THE STATE OF NEW HAMPSHIRE
BEFORE THE
NEW HAMPSHIRE SITE EVALUATION COMMITTEE

DOCKET NO. 2024-02

PETITION REQUESTING JURISDICTION AND OVERSIGHT OF
EVERSOURCE PROPOSED X-178 TRANSMISSION LINE
REPLACEMENT PROJECT

**Public Service Company of New Hampshire Responses to
Technical Session Data Requests**

BEEBE S/S TO WHITEFIELD S/S
115kV TRANSMISSION LINE X178
PLAN AND PROFILE DRAWINGS

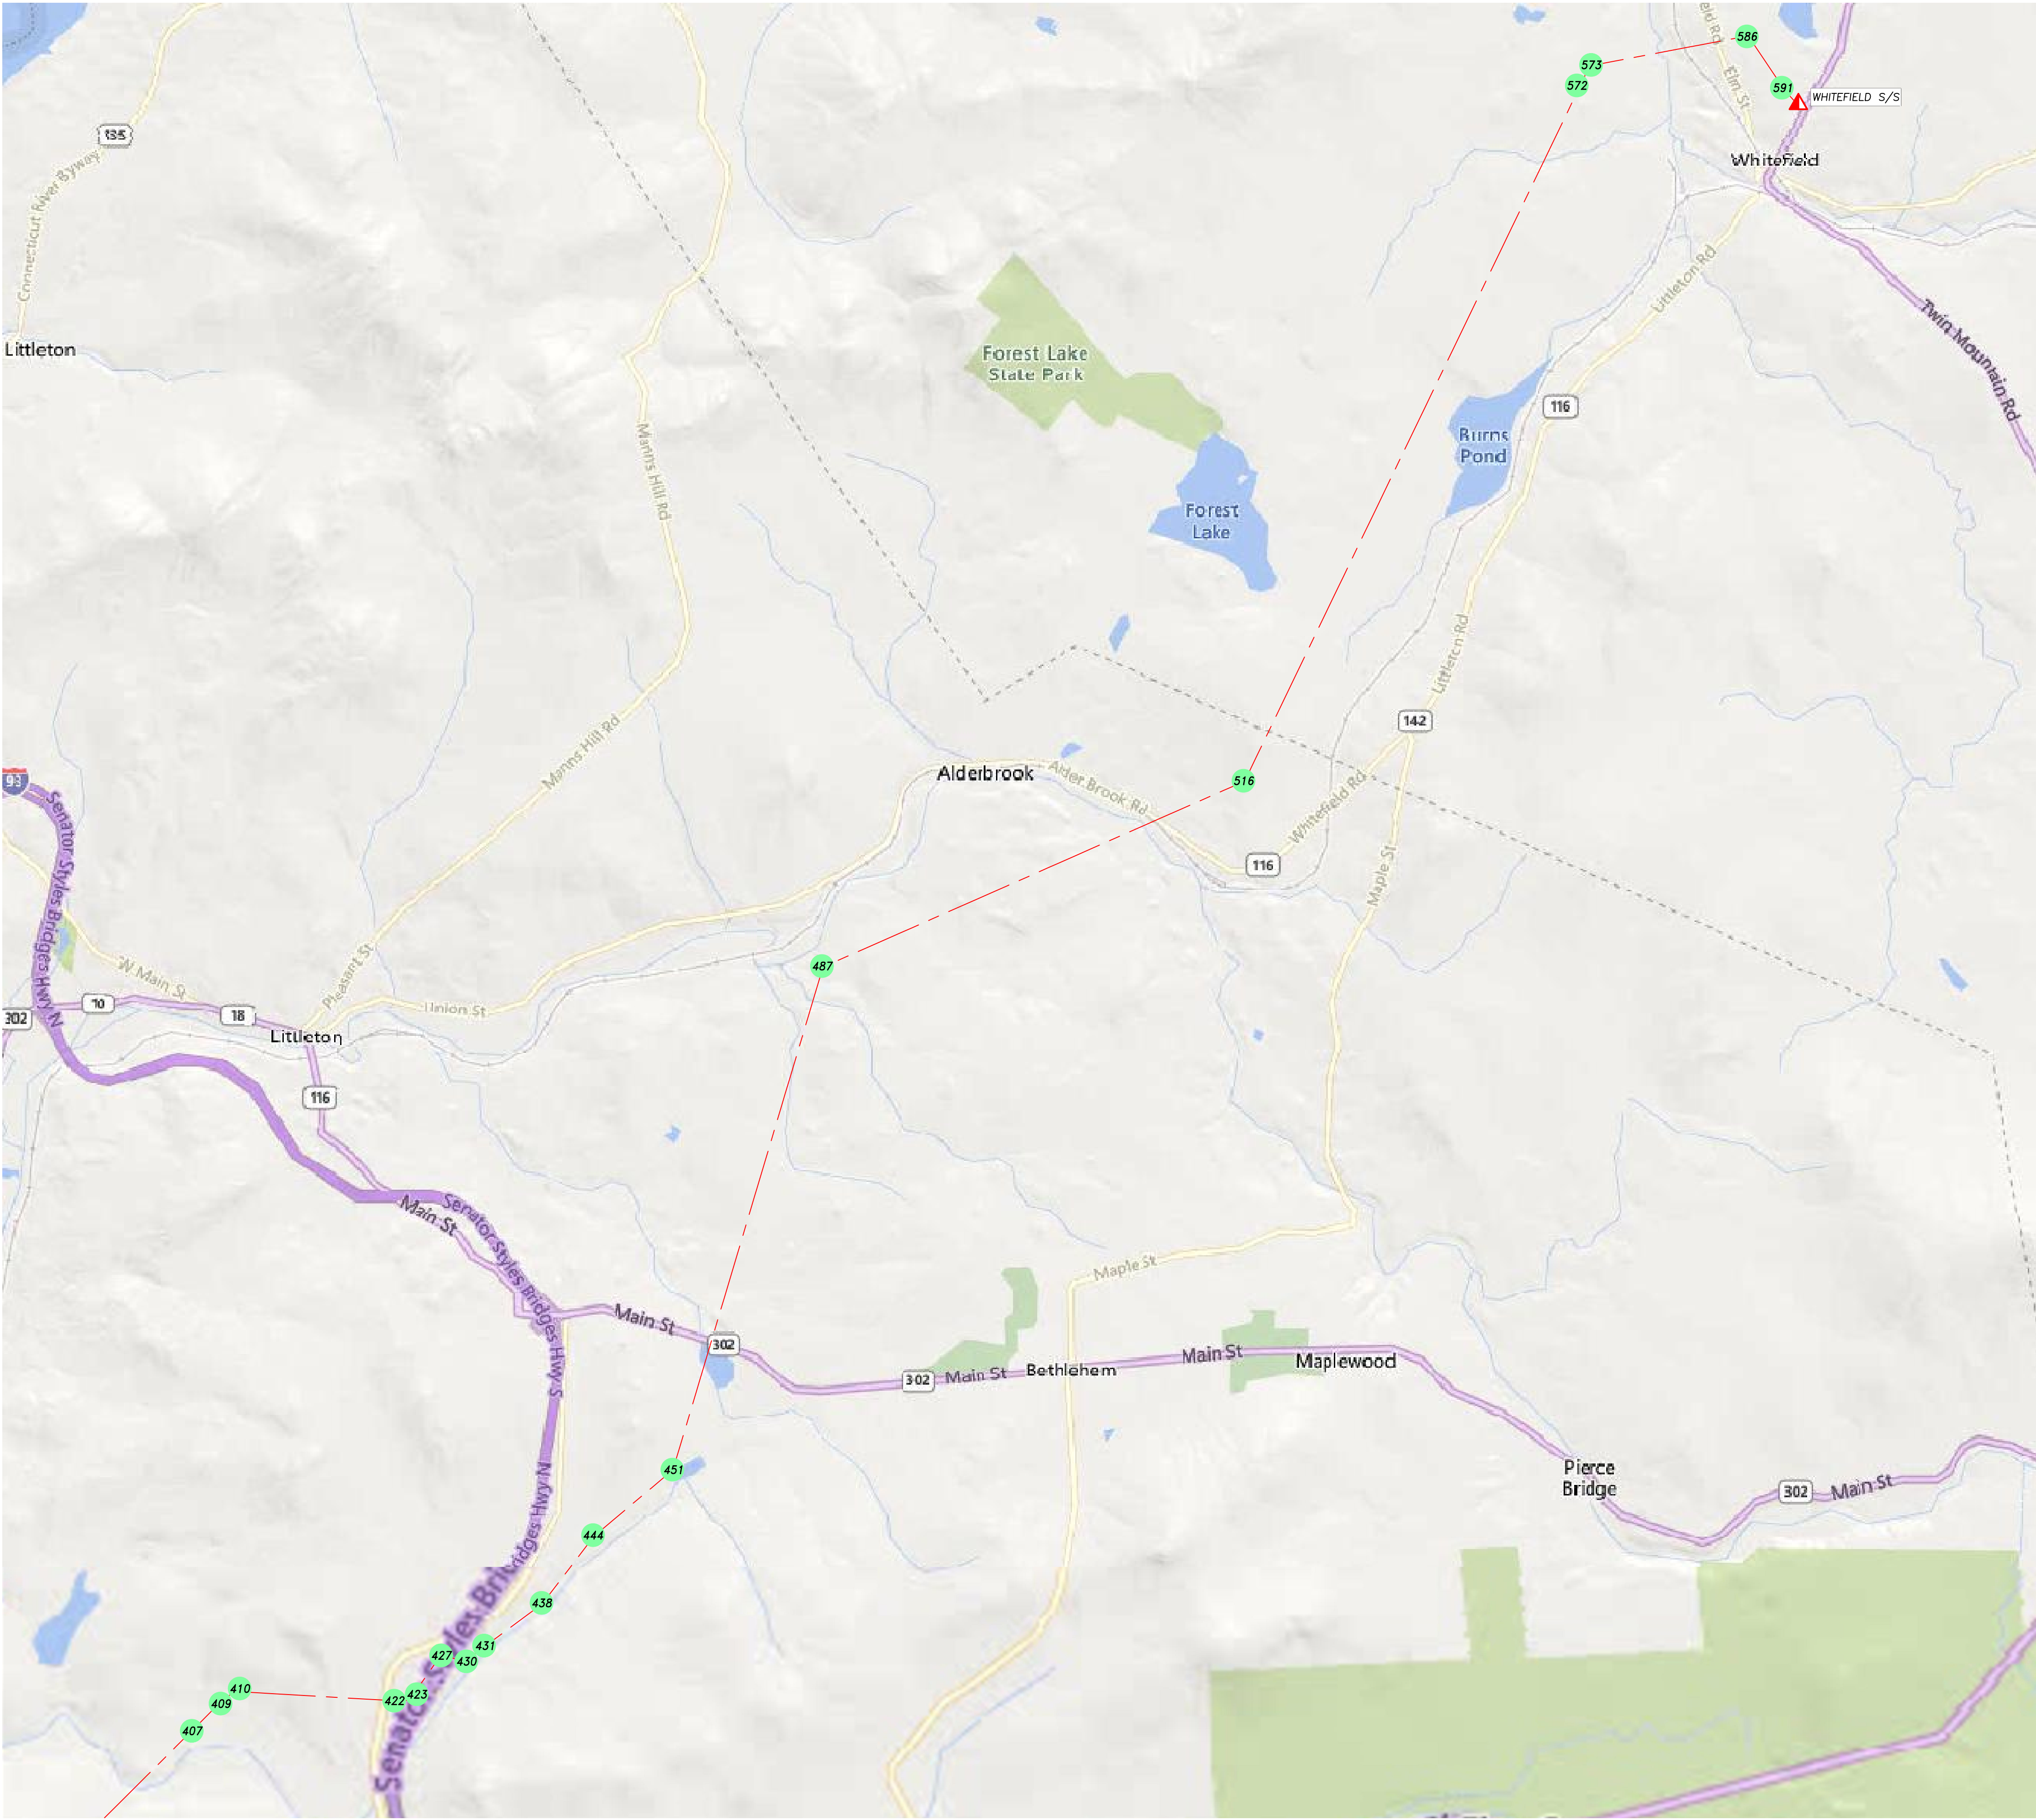
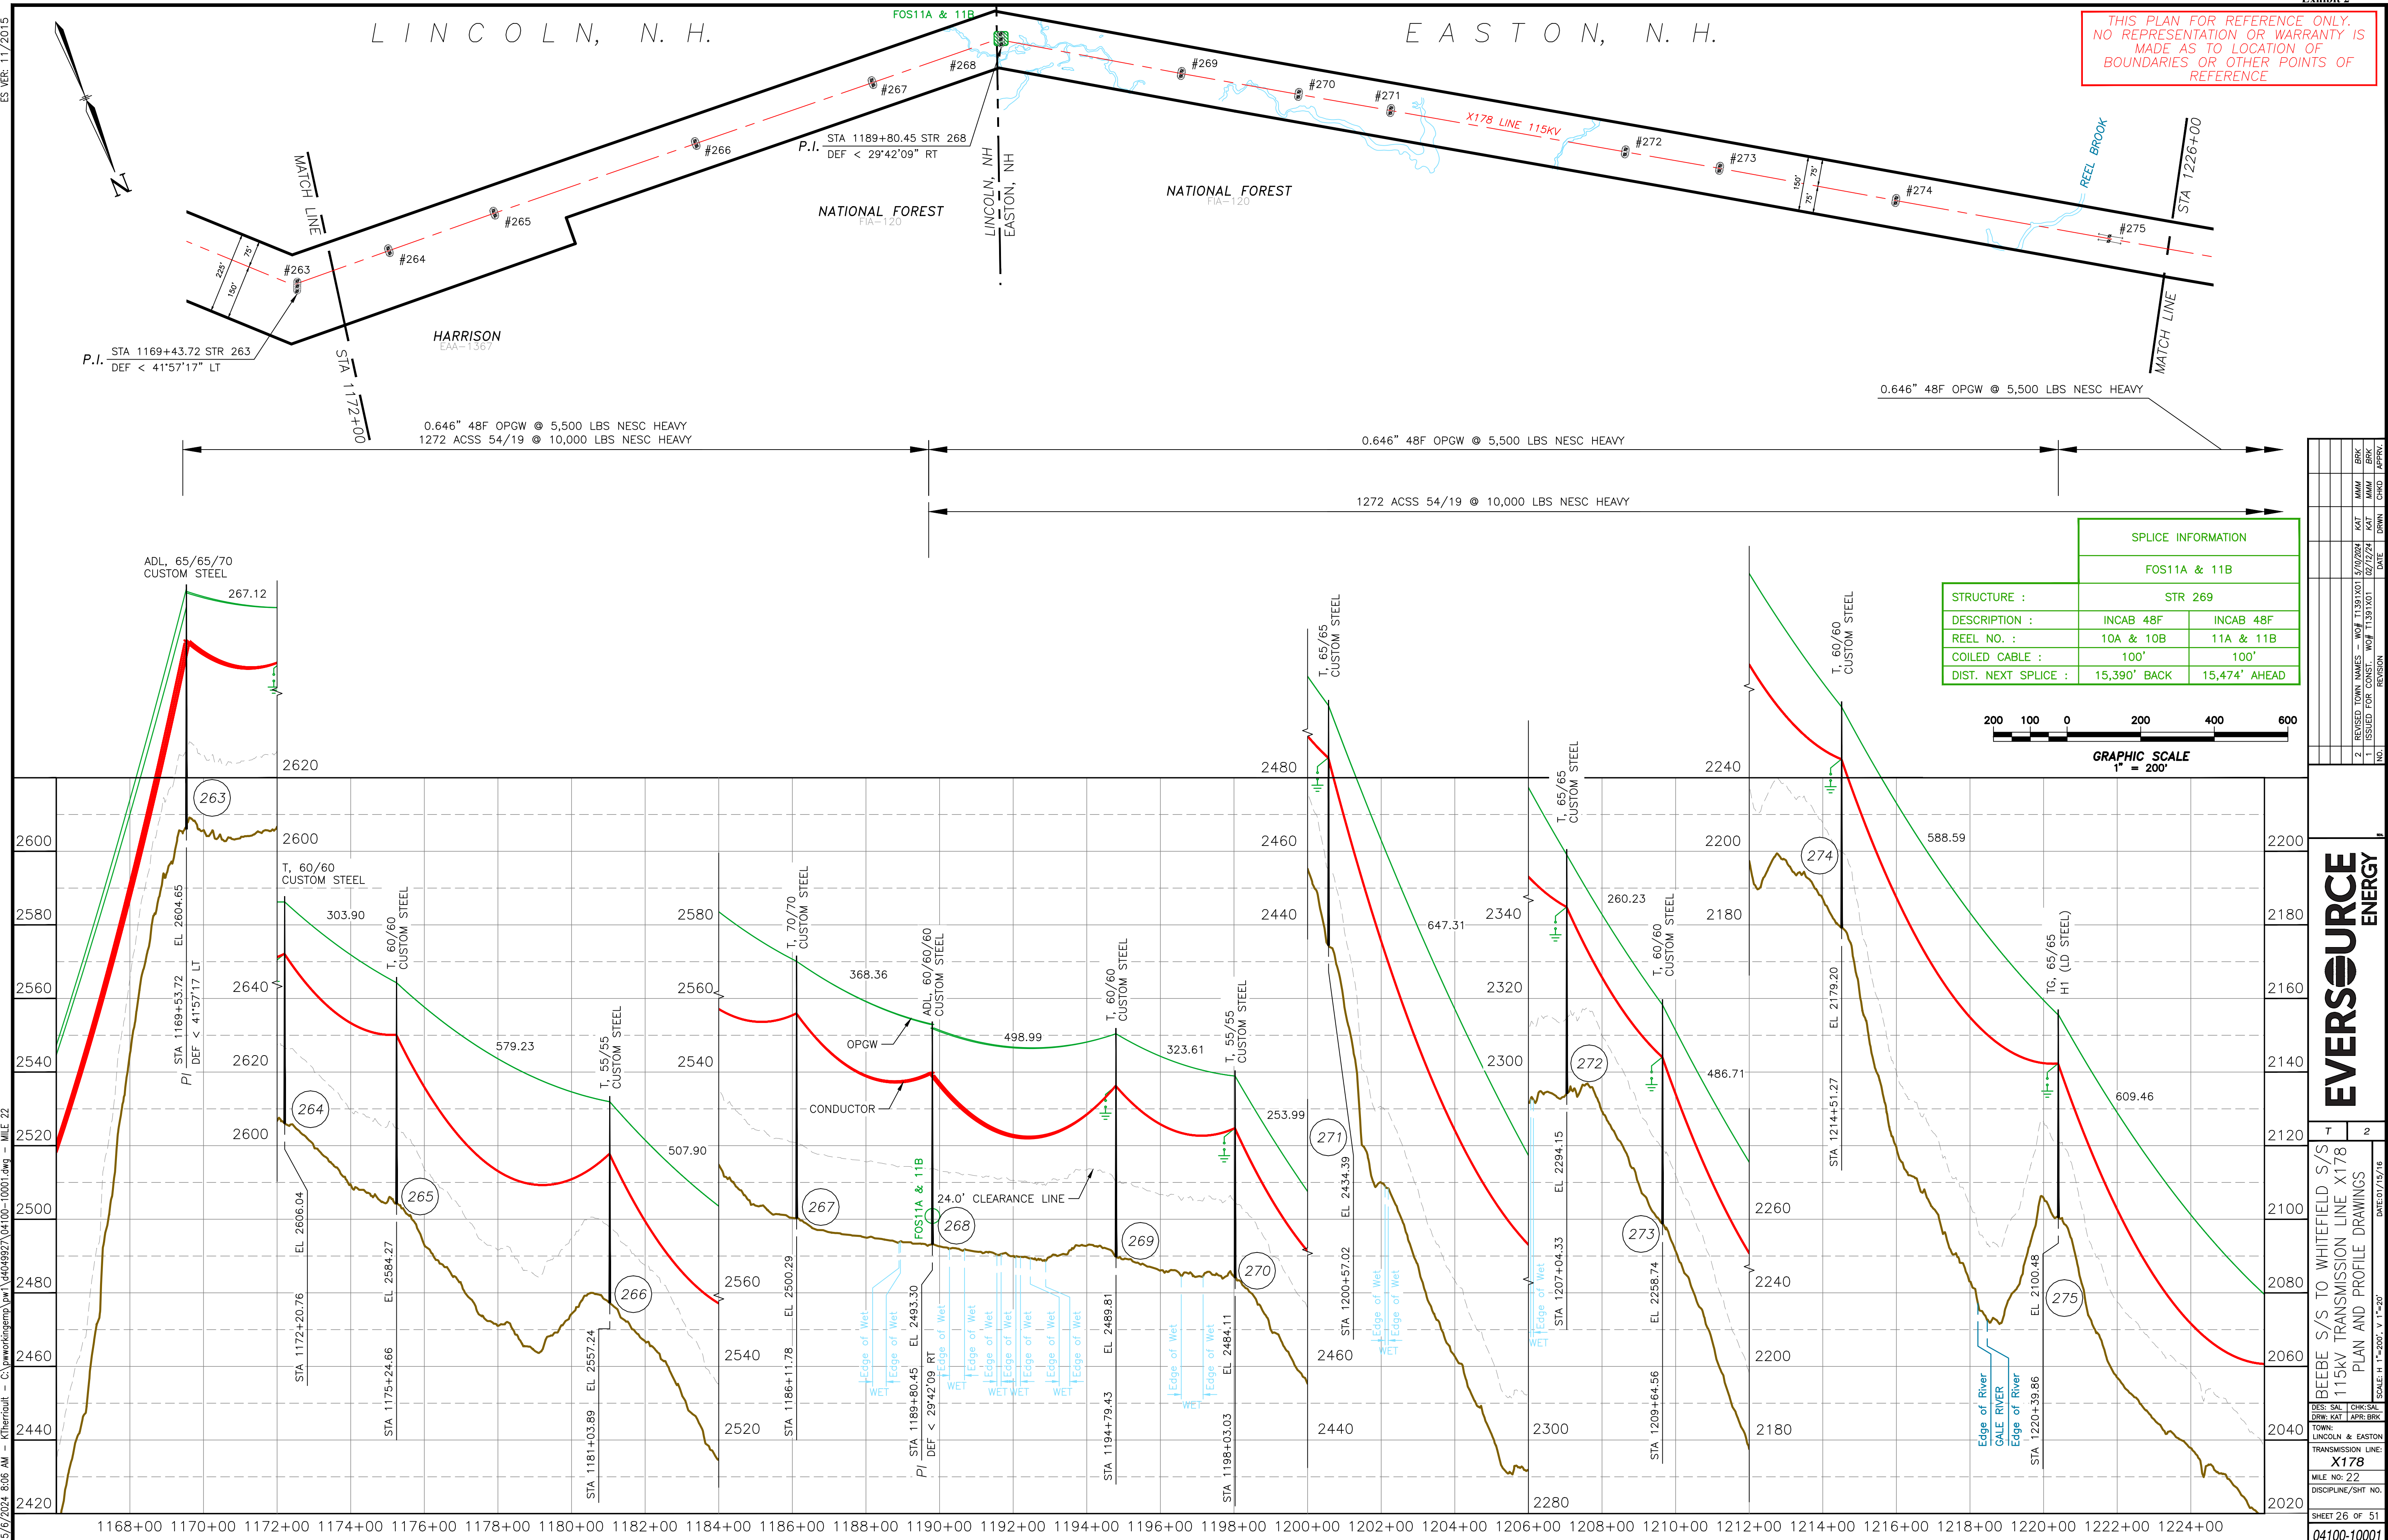
4. Provide profile drawings for the towns of Easton and Bethlehem.

Response: Copies of the profile drawings for the towns of Easton and Bethlehem will be filed as part of the revised Technical Report submitted to the NHSEC. For convenience, the profile drawings are provided to the Town's now as Attachment 1.
